4-1 INTRODUCTION

The purpose of these service notes is to provide technical personnel a convenient source of installation, operation, and maintenance notes peculiar to specific types of radio, radio communications, and associated equipments. These service notes are provided to assist personnel associated with electronics equipment. They do not supersede information contained in the equipment technical manuals; rather, they are intended as supplementary information which will lighten the ever-increasing burden of personnel responsible for the installation and maintenance of electronics equipment.

Figure 2. Signal Line Connections for High Level Signals. Note Terminating Resistor

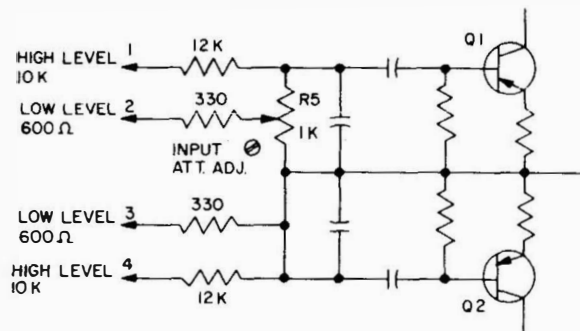
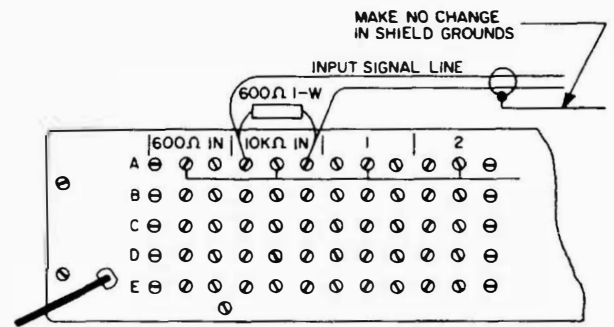
Serious distortion of the input signal can result unless particular attention is paid to the input signal level or to the manner in which the input signal line is connected to the amplifier. For example, the signal level applied to the LOW LEVEL 600 OHM input should never exceed -10 dbm. The reason being that the input attenuator adjustment potentiometer R5 becomes extremely critical to adjust if the input signal level exceeds approximately -10 dbm, see figure 1. Mis-adjustment of the input attenuator adjustment potentiometer R5 can cause the input transistors Q1 and Q2 to be over driven resulting in a seriously distorted output signal. Adjustment of the output level potentiometer will not correct for distortion developed in the input stage of the amplifier.

There are two relatively simple solutions to the problem: (1) install signal line level adjustment pads ahead of the AD-2 Distribution Amplifier and set the level of the input signal not to exceed approximately -15 dbm., or (2) connect the signal lines to the HIGH LEVEL 10K OHM input terminals of the AD-2 Distribution Amplifier, as shown in figure 2.

Since this input is a high impedance input, normally used for bridging applications, the signal line should be terminated with an impedance approximating 600 ohms. The value is not critical and a 620 ohm $\pm 5\%$, 1 watt resistor, FSN 9N-5905-279-2629, is satisfactory. This manner of connection will accommodate signal lines on which the signal level nominally averages between -10 dbm and +1 dbm.

FIGURE 2.—Revised arrangement

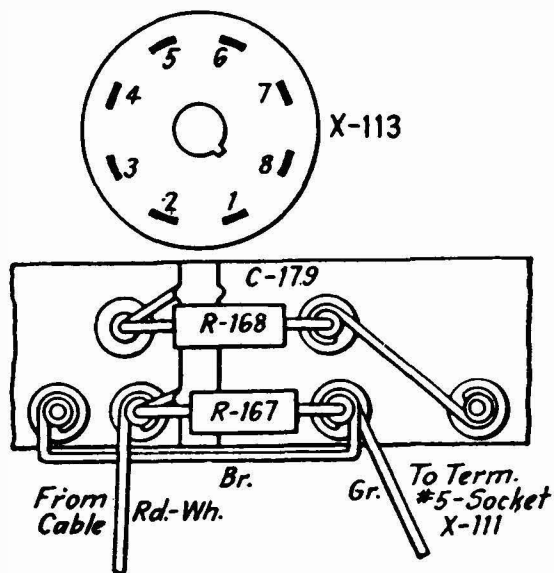
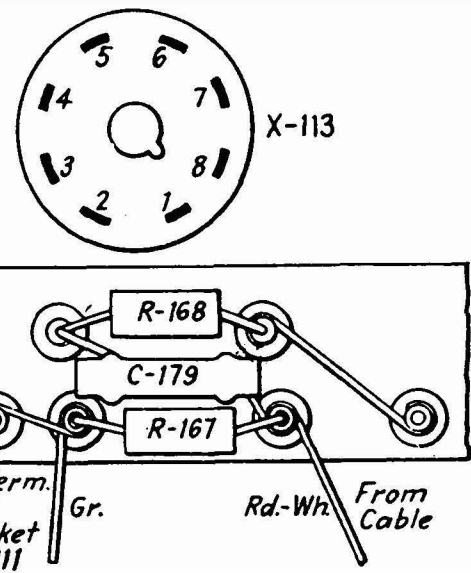
Investigation of several failures of capacitor C-179 in AN/ARC-1 equipments has led to the conclusion that the mounting arrangement should be changed as shown in Figures 1 and 2 and a capacitor with higher voltage rating substituted.

Electrical test on a quantity of these capacitors taken from the production line at Western Electric has shown that they are not adequate for this circuit application. In addition, the capacitor is mounted in the set as shown in figure 1 and may possibly have become misplaced to such an extent that the end nearest to tube socket X-113 was actually in contact with the terminals projecting from the socket. In this case the bakelite insulation on the condenser would soon wear through and result in a contact between the grounded end of C-179 and socket terminal No. 2 (heater terminal 18 volts) or No. 3 (plate terminal). It is believed, therefore, that the difficulty might be due either to random defective condensers or misplacement in the assembly or both.

Equipments commencing with Western Electric serial No. 5700 and Westinghouse serial No. 11663 will be modified to avoid trouble due to misplacement of this capacitor, by rearranging the terminal board on which it is mounted, as shown by Figure 2, and by substituting a 200-mmfd. 500-volt capacitor.

Perhaps a warning to service men that C-179 should have at least 1/8" clearance from the terminal of socket X-113 is all that is warranted although the change is one that could be readily made at any repair shop. This change will also be shown on the wiring diagram, Figure 43, of the maintenance handbook when it is reissued.

figure 1.

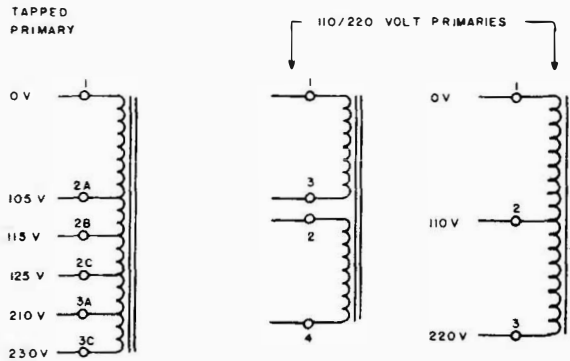
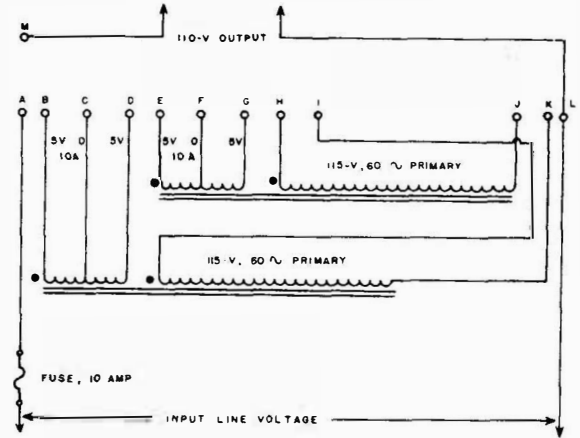
Later procurements of the AN/FRA-501 and AN/FRA-19 (V) and AN/FRR-502 and AN/FRR-49(V) equipments were provided with power transformers having tapped primaries to enable adjustment for input voltages from 105 volts to 230 volts A.C. Information is not available as to which serial numbers apply to the later equipments. The instruction books released with the equipments do not necessarily reflect the correct information regarding the type of power transformer used; therefore, it will be necessary to visually inspect each power transformer in the system to determine which type transformer is installed in the equipment.

The type of transformer in use can be determined by comparing the notation on the transformer primary connections with the notations for three different transformers shown in figure 1.

Activities using any of the equipments (or components thereof) listed in the subject for this article are directed to inspect their respective equipments to ascertain if the power transformers have 110/220 volt primaries or if tapped primary power transformers are used. Those activities finding 110/220 volt transformers in their equipment are further directed to take remedial action as necessary to correct the deficiency at the earliest opportunity.

The simple auto-transformer arrangement shown in figure 2 is recommended because it provides the most economical method of voltage reduction using readily obtainable parts. The arrangement is designed to supply a 5 to
